November 11, 2019

Updated Focused Traffic Study for the Fox Den Dispensary

Response to Comments on the “Focused Traffic Study for the Fox Den Dispensary”

Stopping Sight Distance Exhibit

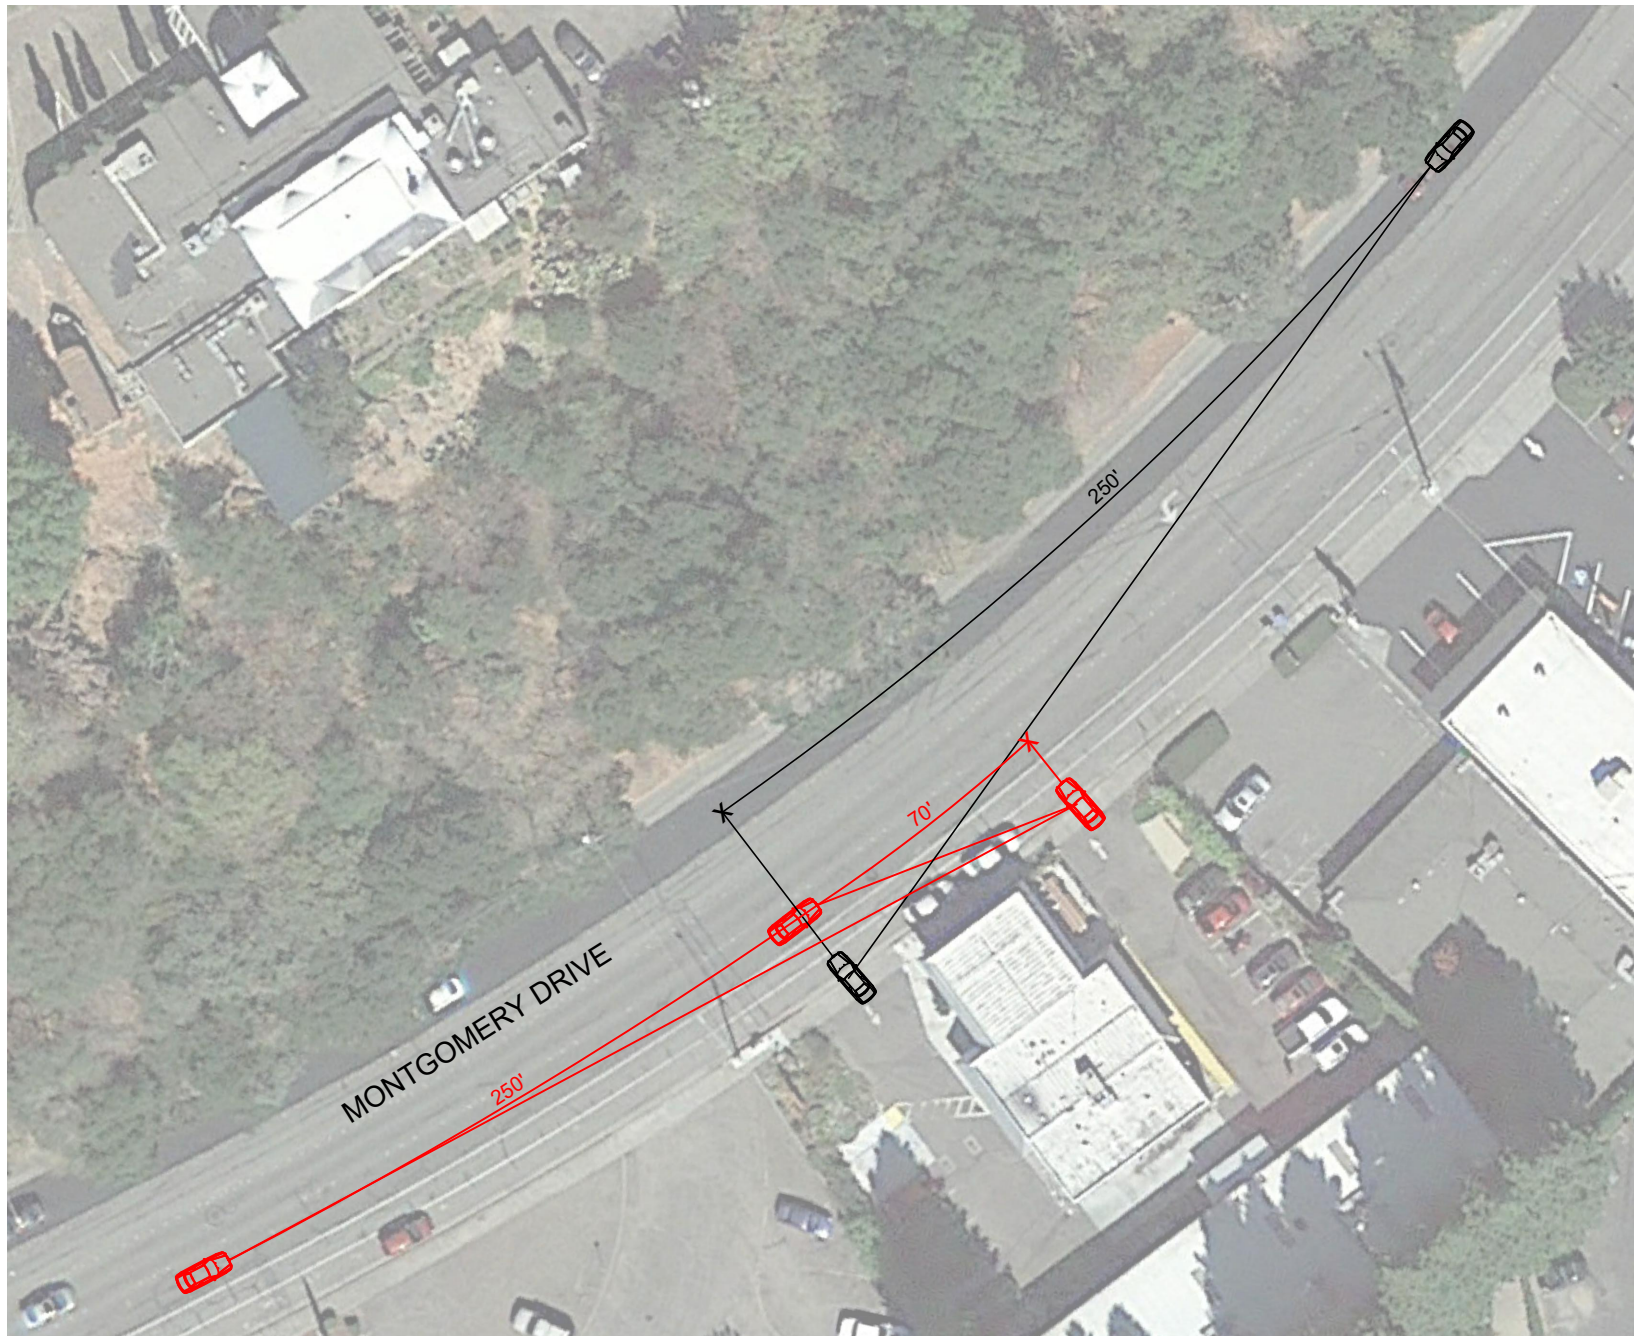
For the posted 35-mph speed limit on Montgomery Drive, the recommended stopping sight distance is 250 feet. Based on a review of field conditions, sight distance at the northeastern driveway extends approximately 300 feet to the northeast, which is more than adequate for the posted speed limit. To the southwest, sight distance can be restricted to as little as 70 feet if a vehicle is parked in the street parking space directly adjacent to the driveway, which is inadequate for the posted speed limit. In this situation, adequate sight lines can be achieved by pulling forward into the bike lane, but this type of operation is not preferred for extended periods of time. Field observations confirmed that drivers exiting the site routinely pull into the bike lane to achieve adequate sight lines. In order for

adequate stopping sight distance to be provided with the current circulation direction, the first street parking space directly southwest of the driveway would need to be removed.

Finding – In its current configuration, sight distance to the southwest is inadequate when the first street parking space adjacent to the northeastern driveway is occupied, but by reversing on-site circulation adequate stopping sight distance would be available.

As proposed, the direction of on-site circulation would be reversed so that the northeastern driveway would be used for ingress and the southwestern driveway would be used for egress. Sight lines for this modified circulation pattern were field measured at the southwestern driveway. Based on a review of field conditions, sight distance at the southwestern driveway extends approximately 250 feet to the north and further to the south, which is adequate for the posted speed limit. By reversing on-site circulation stopping sight distance would be adequate and it would not be necessary to prohibit parking for the first 20 feet of curb southwest of the driveway, as originally recommended in the January 23, 2019 traffic study. An exhibit showing the available stopping sight distance when two vehicles are parked between the driveways with both the existing and proposed access conditions is enclosed.

Recommendation – The direction of on-site circulation should be reversed from its current configuration, as shown on the site plan.

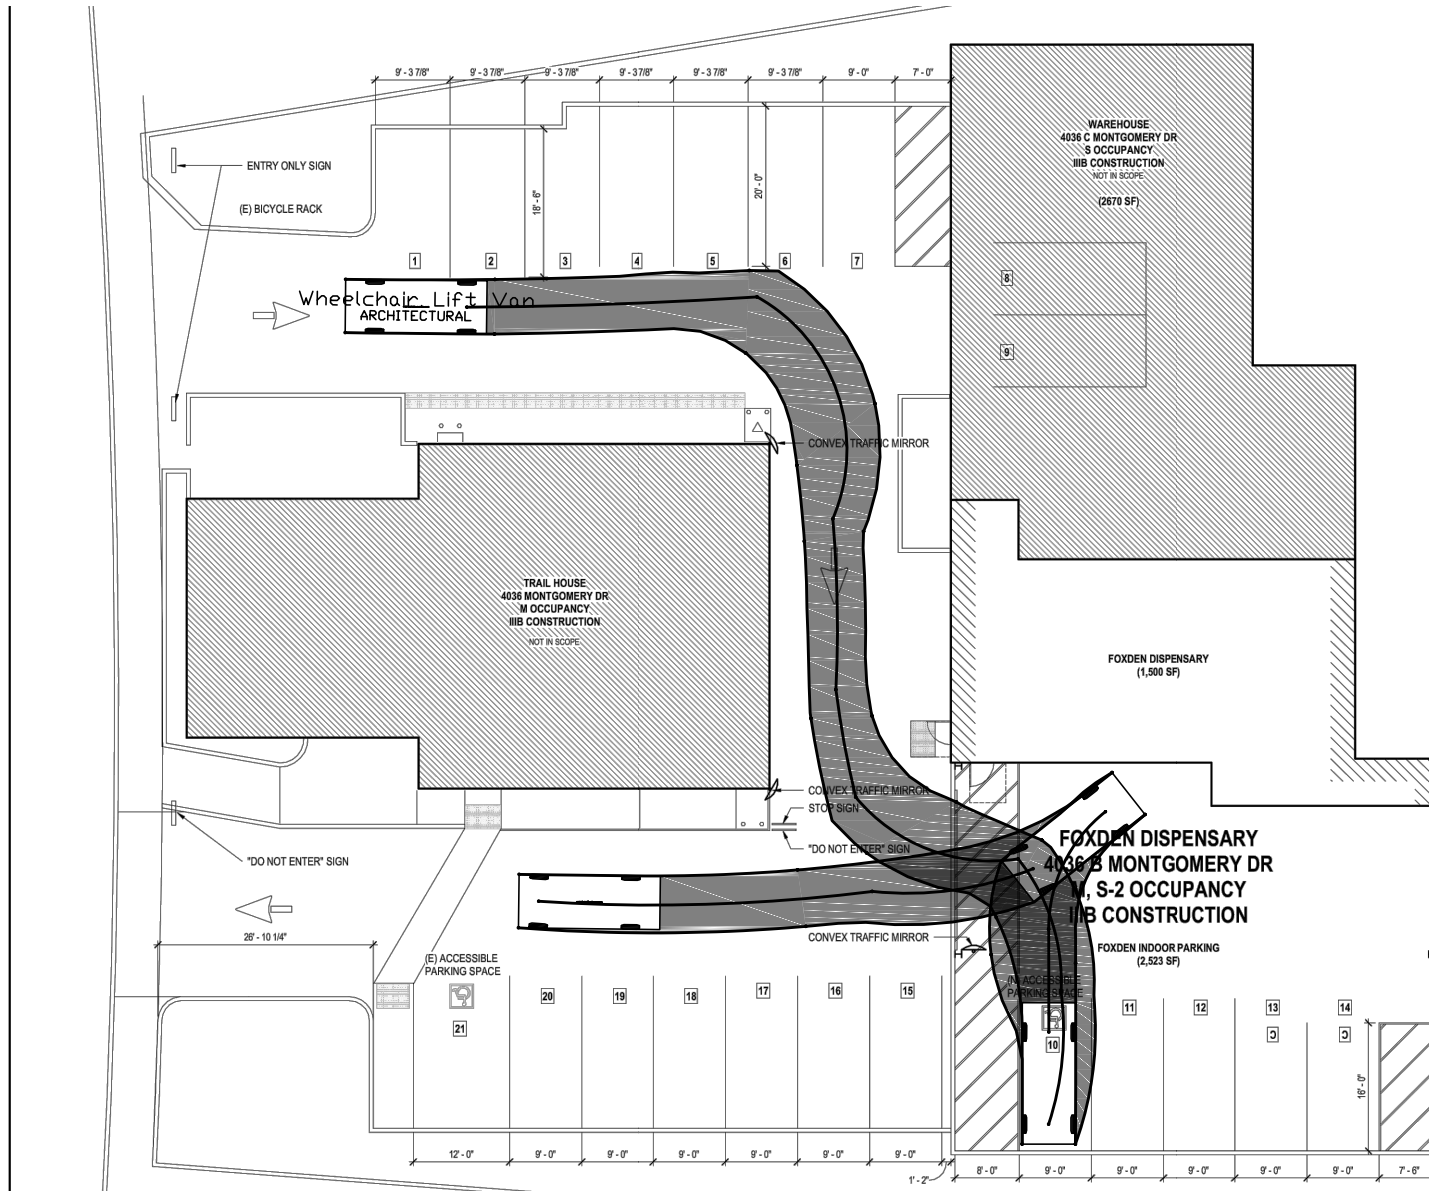
1. *The forecast of vehicle trip generation provided in the April 17, 2018 Focused Traffic Study was based on standalone Marijuana Dispensaries that do not include delivery operations – therefore underestimating the volume of traffic that would be generated.*

- The proposed supply of just seven motor vehicle parking spaces does not appear adequate to serve the number of vehicles associated with the proposed dispensary and delivery option, taking into account both the volume of predicted traffic and ITE parking demand data.*

4. *The turning movement analysis provided in the Focused Traffic Study is based on typical passenger car sizes (not trucks, SUVs or delivery vehicles), and therefore does not provided a full analysis of the potential range of vehicle movements that would be required to access the seven parking spaces to be provided.*

On-site circulation was modeled in the focused traffic study for Fox Den using a standard passenger vehicle as deliveries would be made by a Toyota Prius, or another similar vehicle. To show that larger vehicles such as SUVs, trucks, or vans would be able to navigate the site as intended, circulation was also modeled for a 20-foot shuttle van. As shown in the enclosed AutoTURN exhibits, on-site circulation would operate acceptably for standard passenger vehicles as well as shuttle vans. One of the parking stalls would be signed for "15-minute" parking and would be used by the delivery vehicle when loading products between deliveries. The delivery vehicle would be off-site most of the day and loading between runs would take approximately 5 to 15 minutes, so the delivery vehicle would only occupy a parking space for a short period of time when it is on-site.
